BAR Meeting
June 19, 2013

ISSUE: Partial Demolition/Capsulation
Addition and Alterations

LOCATION: 423 South Fairfax

BAR2013-00171 & BAR2013-00172

Illustration showing the 1790s wall to be Capsulated

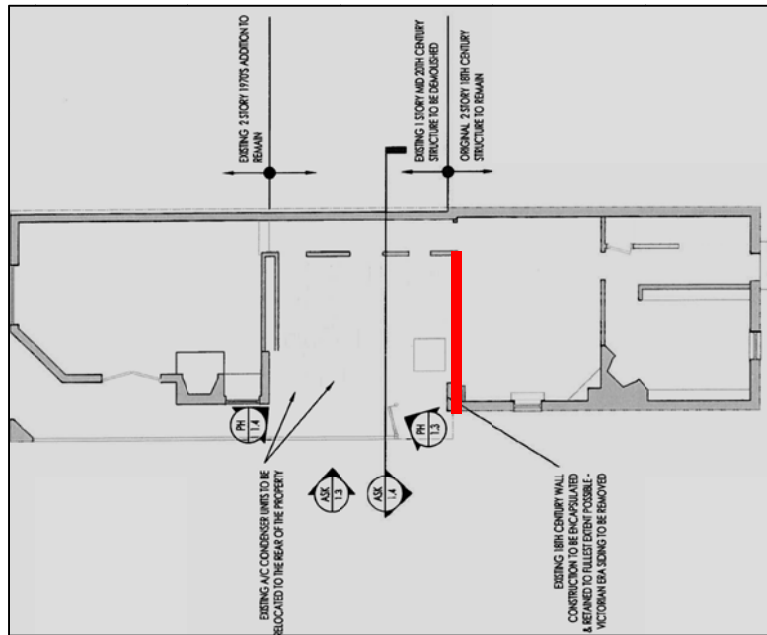
However, the timber framed west (rear) elevation of the c1790s portion of the house is remarkably intact and of great historic interest. The applicant has, therefore, agreed to make every effort to identify and preserve the timber framing and brick nogging in this wall during construction and has identified this on their drawings, so that plumbing risers and wiring will not be extended through this area. Based on a site visit and building permits, the existing wood clapboard siding on this wall is more recent, in poor condition and does not need to be preserved. However, Staff further recommends that any historic rafters and decking of the roof area being capsulated be preserved *in situ*. Staff will flag this address in the City's computer system so that this preservation condition is apparent when future owners apply for building permits for interior alterations.

1. That every effort be made to identify and preserve the timber framing and brick noggin in the west wall of the 1790s portion of the house, both during construction and in the future. Staff further recommends that any historic rafters and decking in the roof area being capsulated be preserved *in situ*.
